## 983 BEACH BLVD

ISSUED FOR HERITAGE REVISION MEETING

**PROJECT ADDRESS:** 983 BEACH BLVD, HAMILTON, ONTARIO  
**PROJECT TYPE:** ADDITION TO EXISTING HOUSE  
**STORIES ABOVE GROUND:** 2 + UTILITY SPACE ABOVE MIN. GROUND LEVEL

1 WEST ELEVATION  
3/8" = 1'-0"

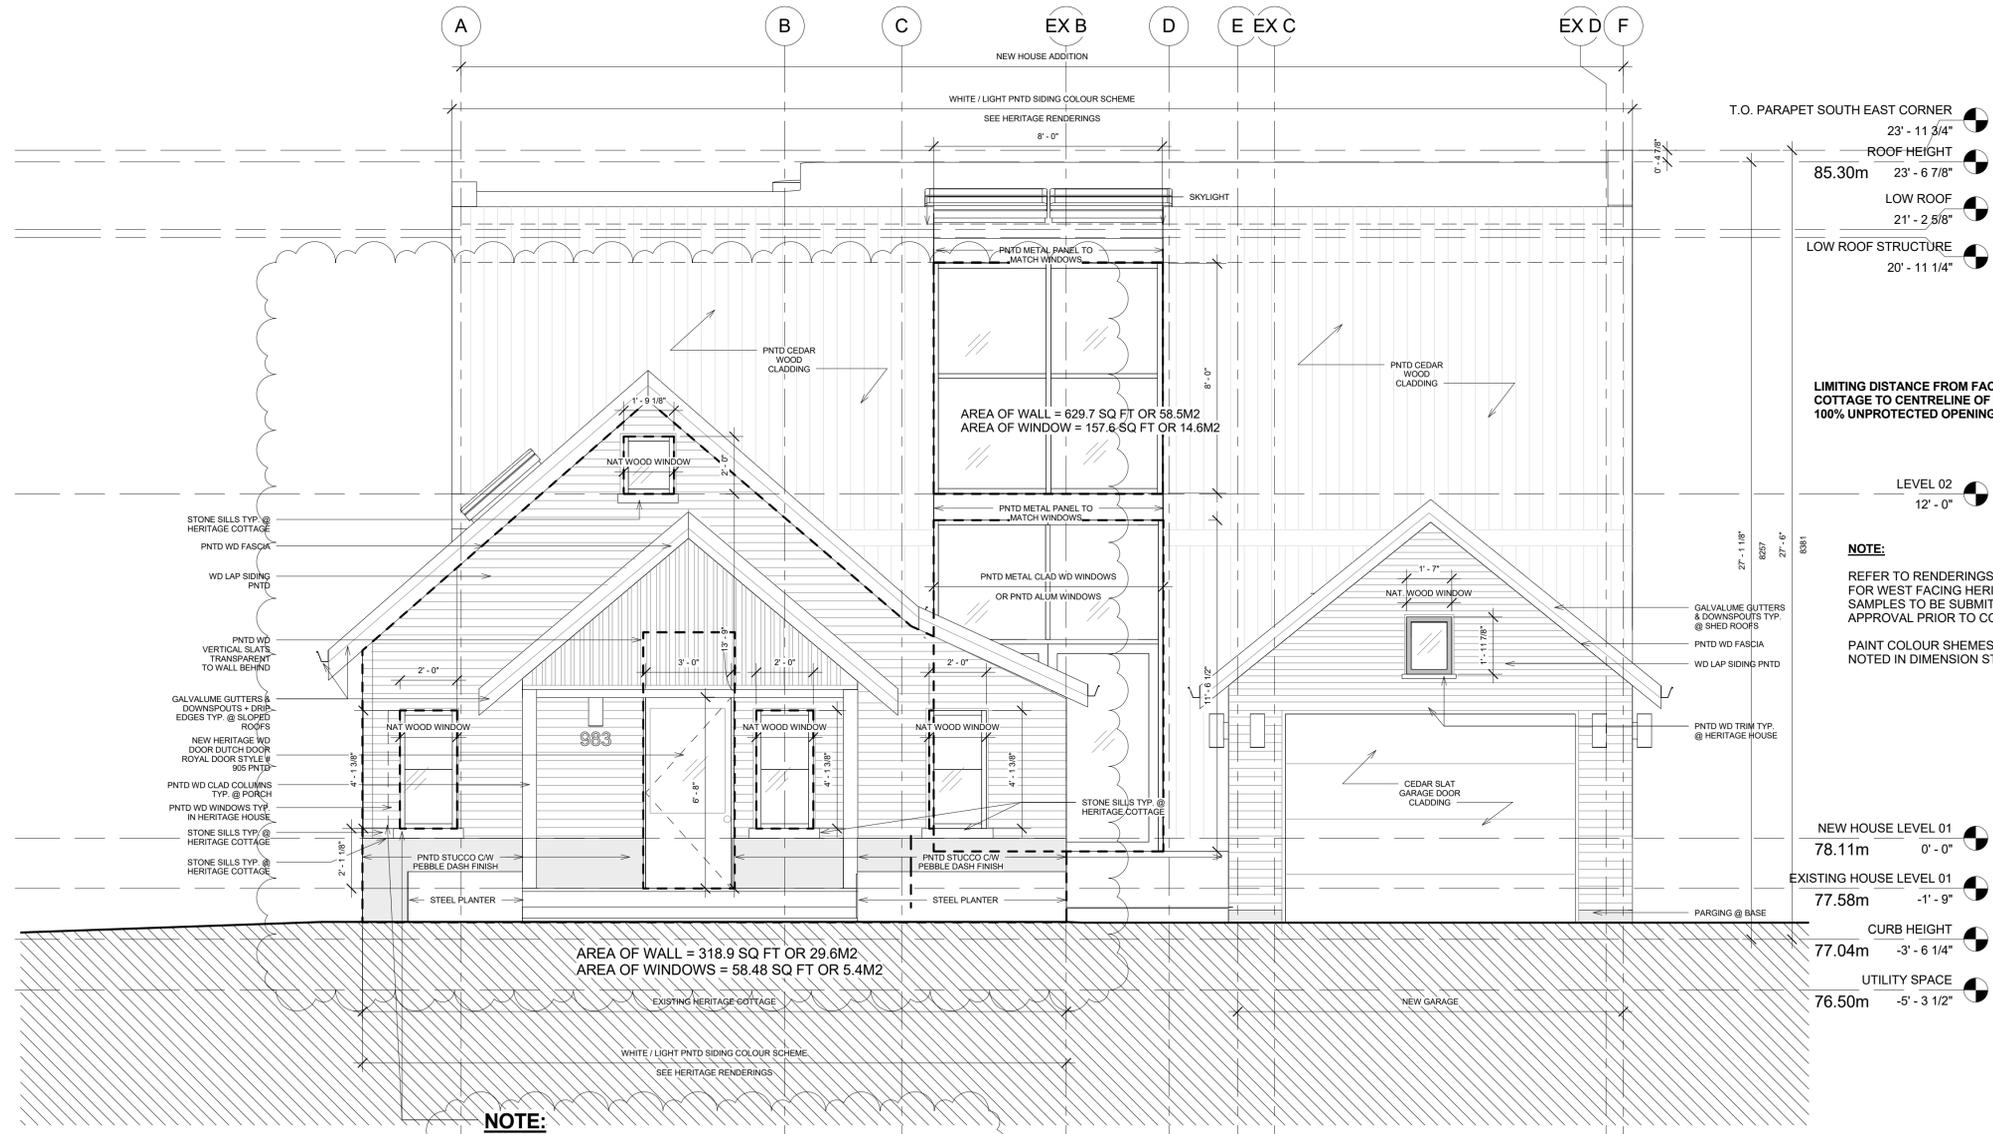
**NOTE:**  
THE ONLY CHANGES TO THE EXTERIOR ARE:

- ONE SLIGHTLY SMALLER WINDOW TO ACCOMODATE INCREASED THICKNESS OF WALLS DUE TO O.B.C. REQUIRED INSULATION VALUES
- CHIMNEY OF COTTAGE WAS REMOVED

1 NORTH ELEVATION  
3/8" = 1'-0"

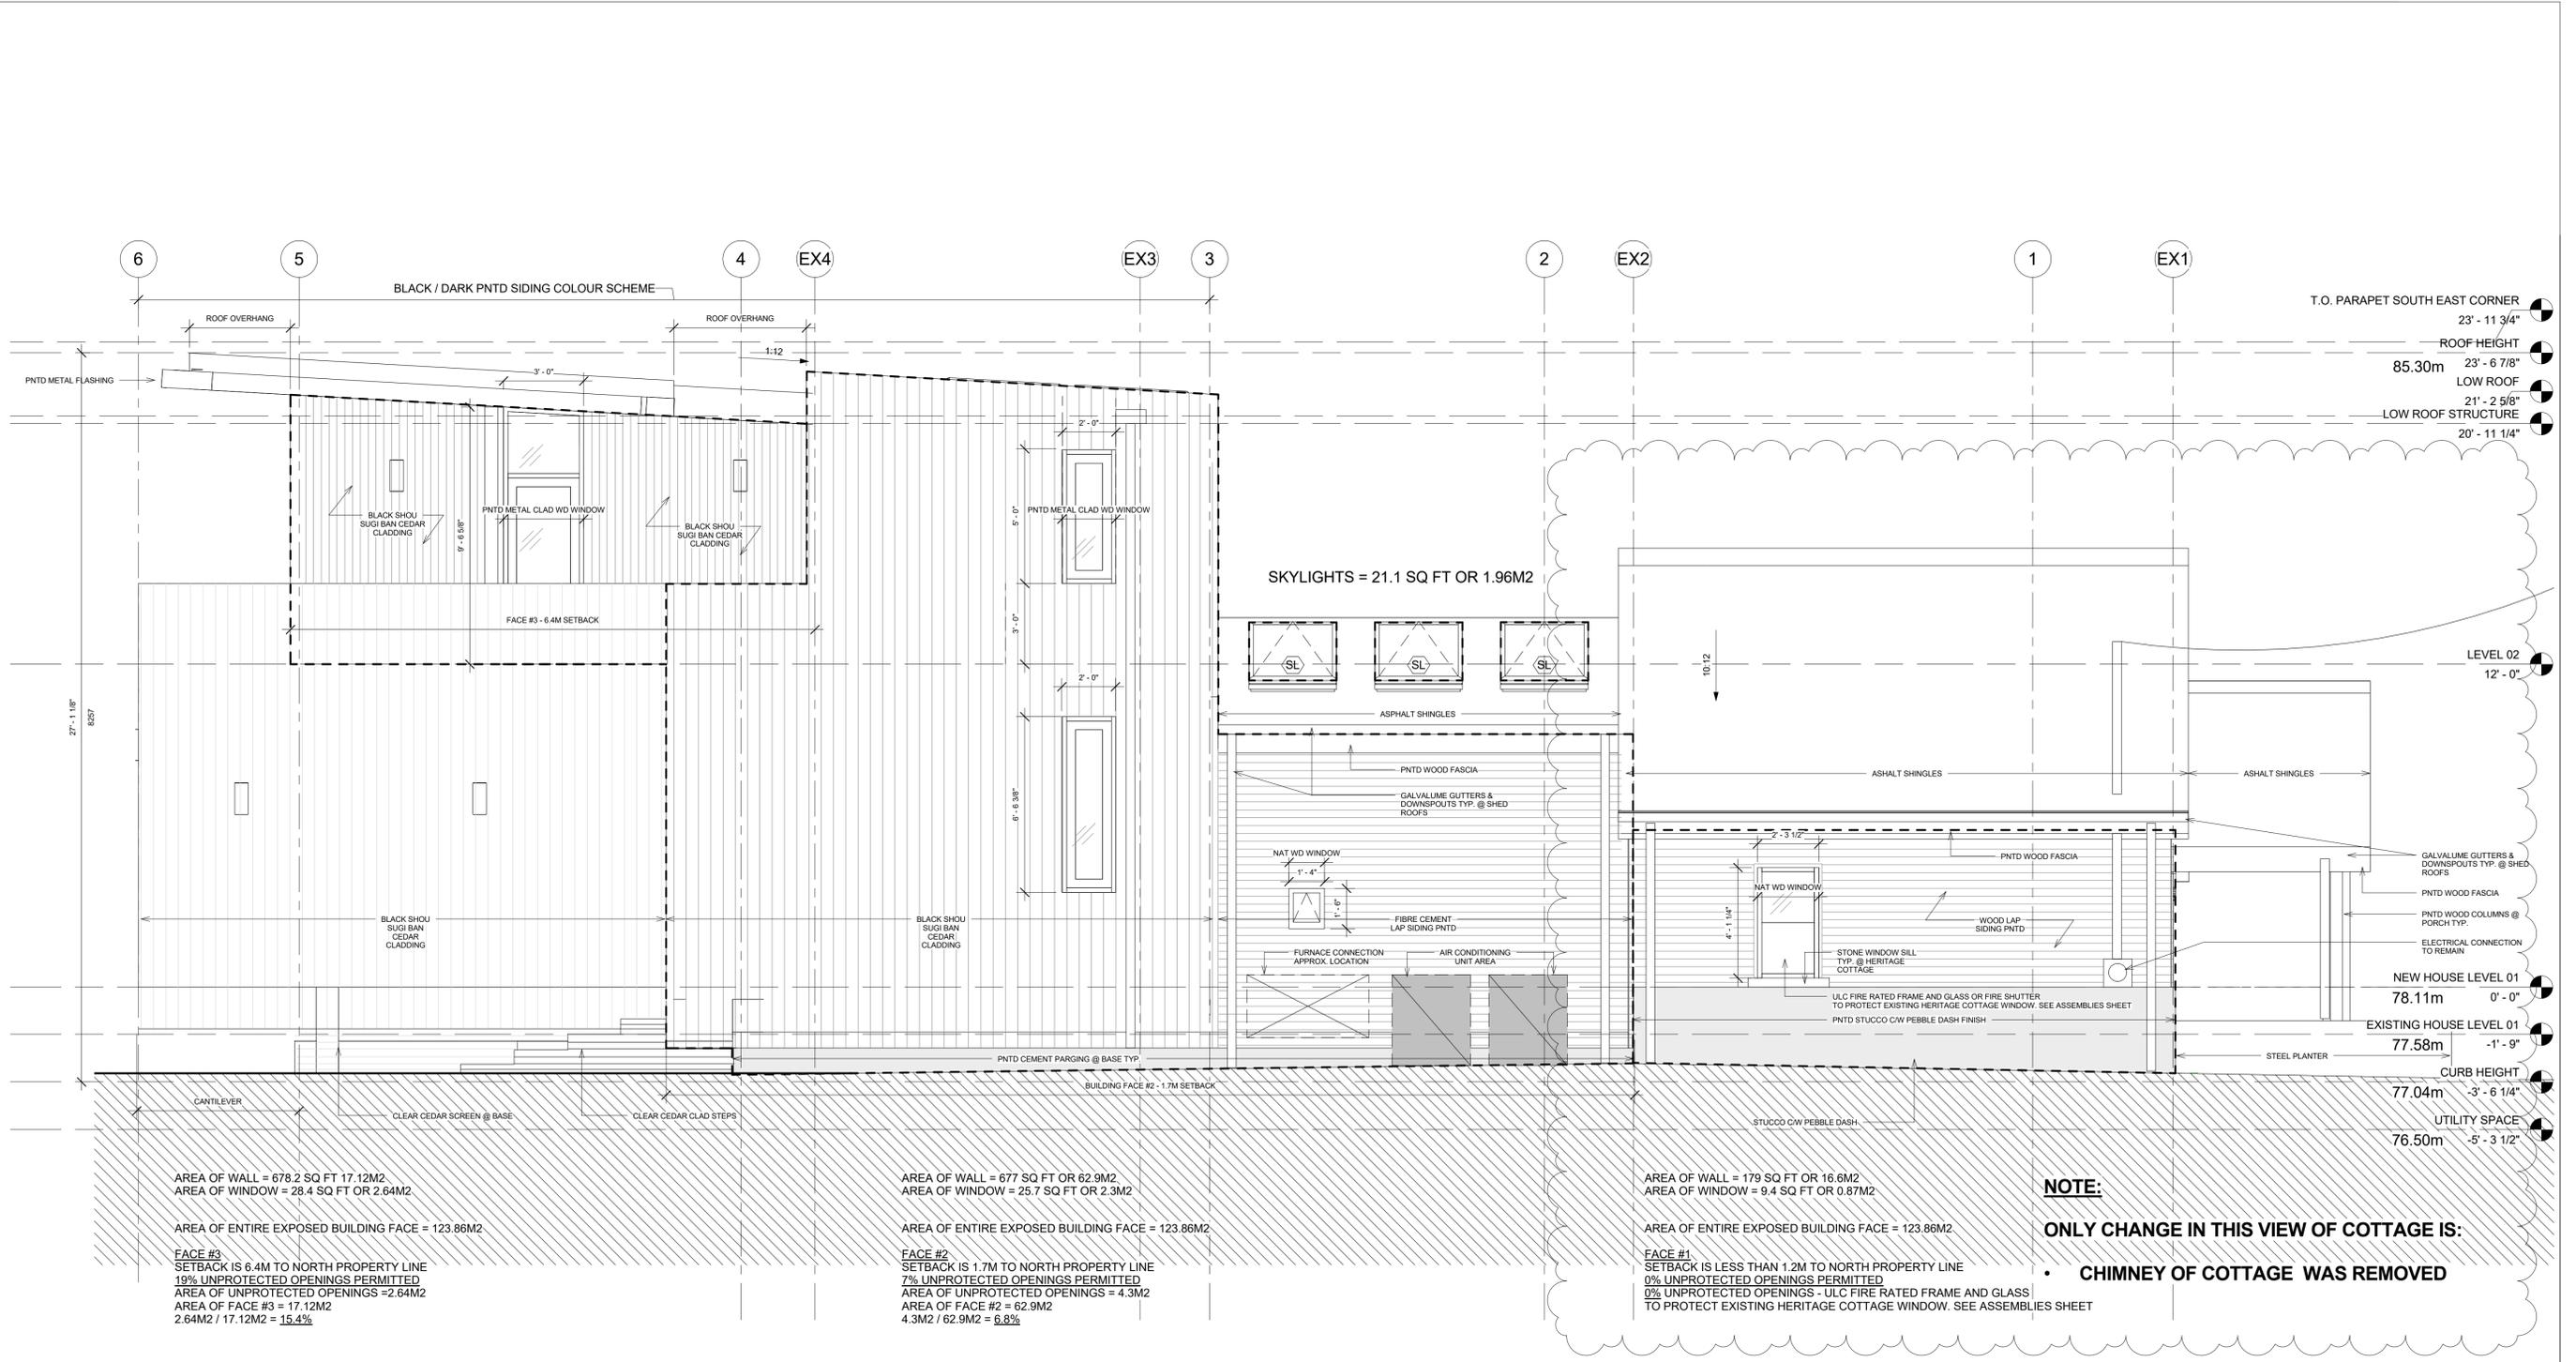
**NOTE:**  
 ONLY CHANGE IN THIS VIEW OF COTTAGE IS:  
 • CHIMNEY OF COTTAGE WAS REMOVED

ELEVATION  
 A2.02

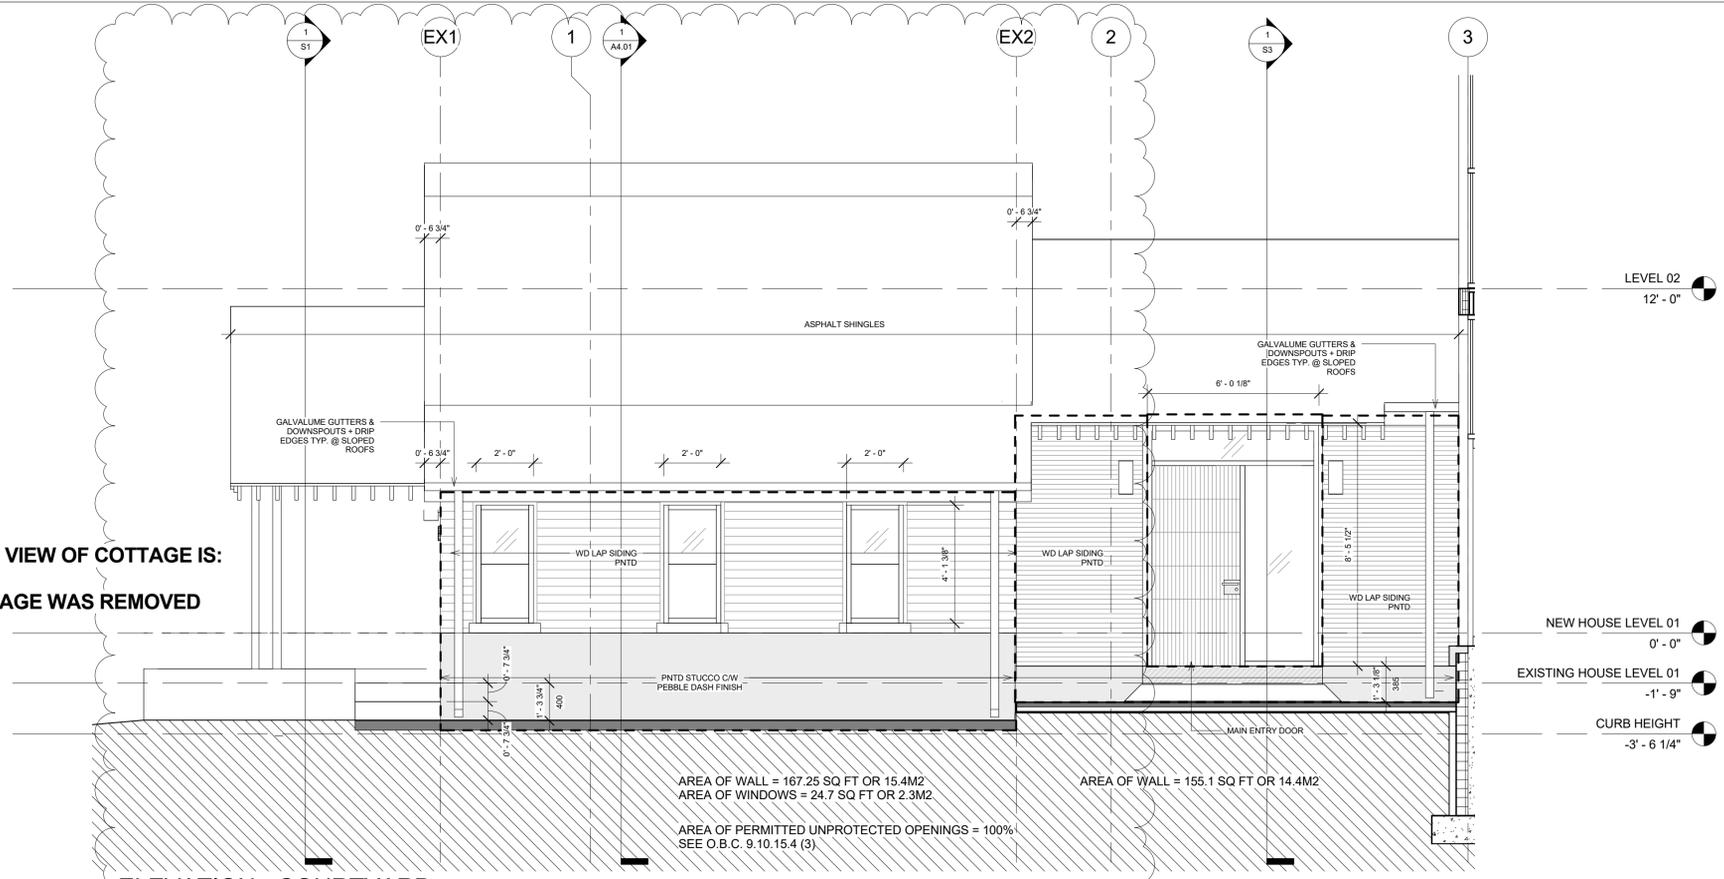
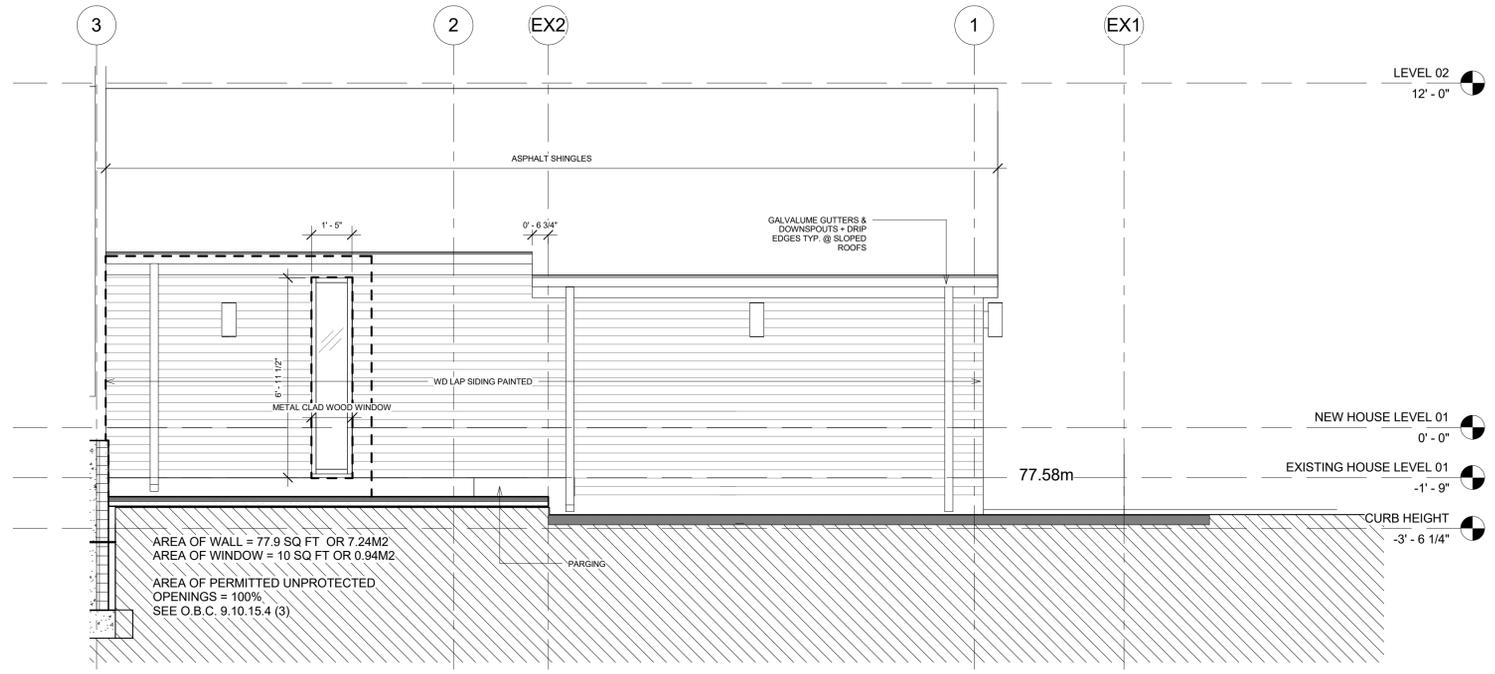
**NOTE:**  
ONLY CHANGE IN THIS VIEW OF COTTAGE IS:  
• CHIMNEY OF COTTAGE WAS REMOVED
